PEMEX EXPLORACION Y PRODUCCION  
Gulf Tertiary Oil Production Asset  
APATG Contract Residence

Subject: Response to the official letter 44-2013 and status report of the BISSELL 1 equipment for contract 424043804

Regarding Contract No. 424043804, related to: "Comprehensive Works for Interventions to Ground Wells in the Northern Region (package I), executed with BISSELL CONSTRUCCIONES E INGENIERÍA S.A de C.V. AND MWS MANAGEMENT, INC. (Joint Proposal) and in response to official letter BISSELL-MWS-44-2013 dated August 20, 2013; we inform you of the status of the equipment called BISSELL 1 according to the review performed last Monday, August 19, 2013.

Figure 1

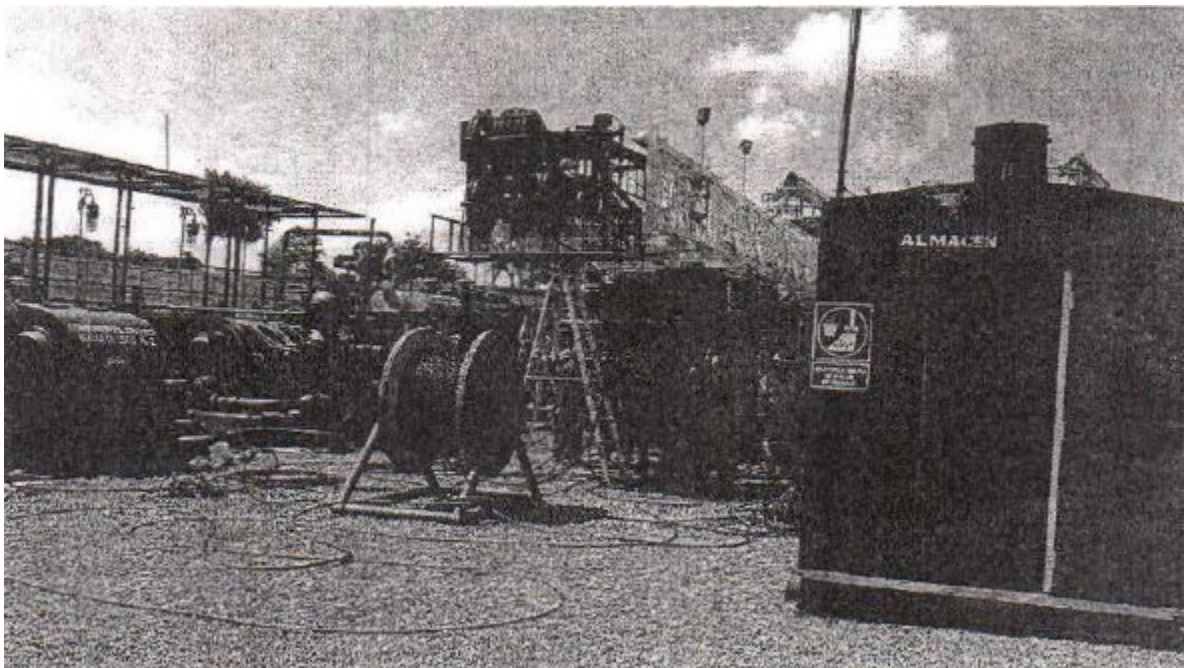
The equipment is not yet complete in all its equipment components

Figure 3

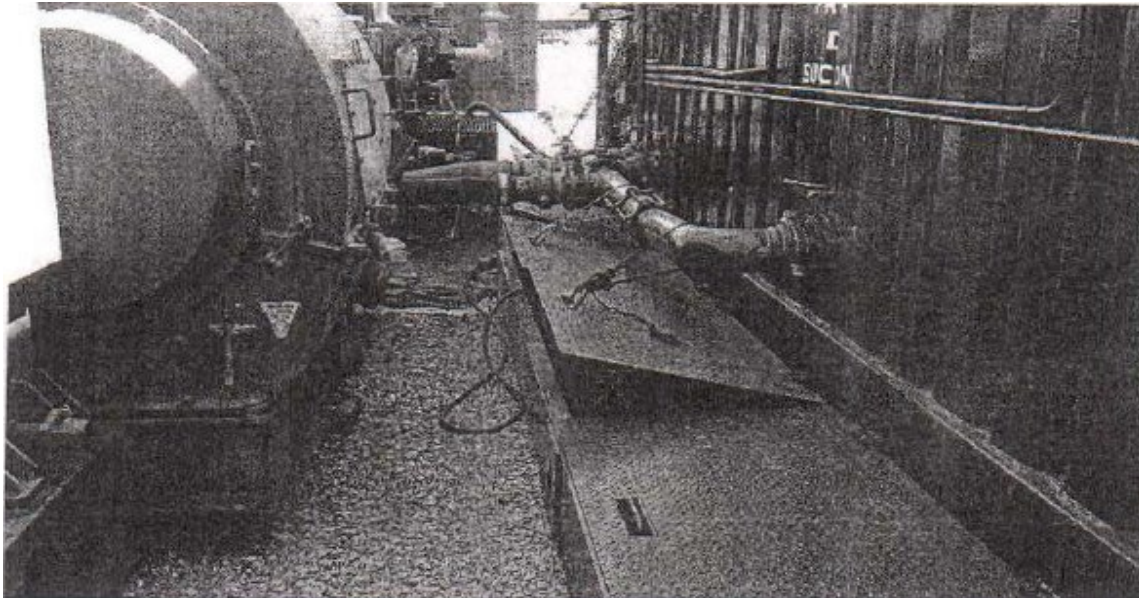
The installation of connections is still in process.  
Lacking the technical reports of the same.  
and the corresponding certifications.

Figure 5

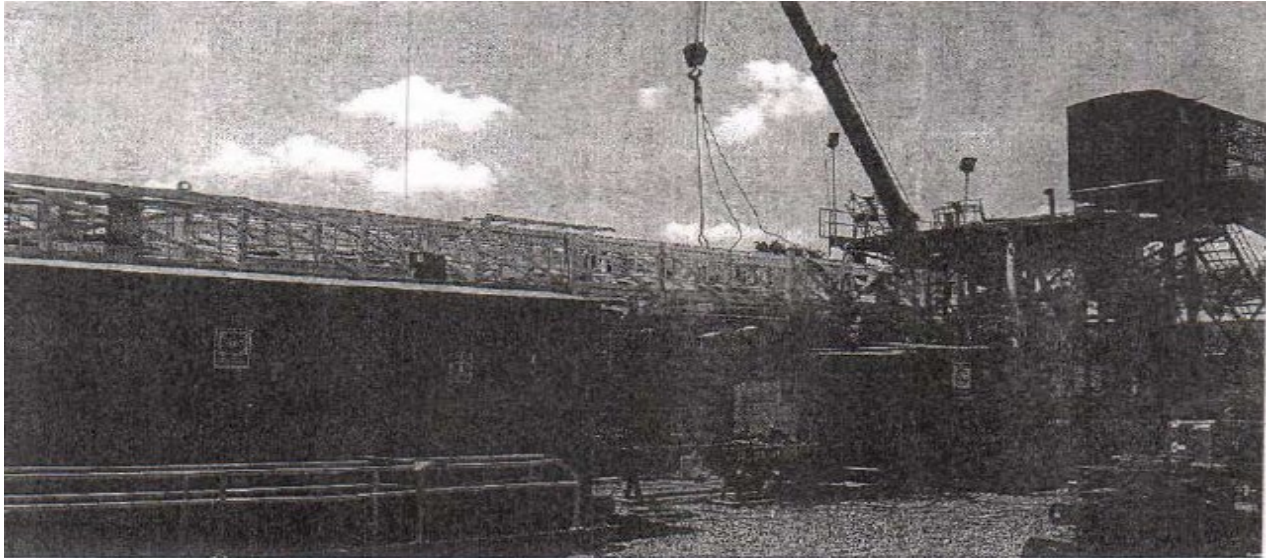
It is noted that several components of the equipment are still in the process of repair.  
of repair of various components of the equipment.
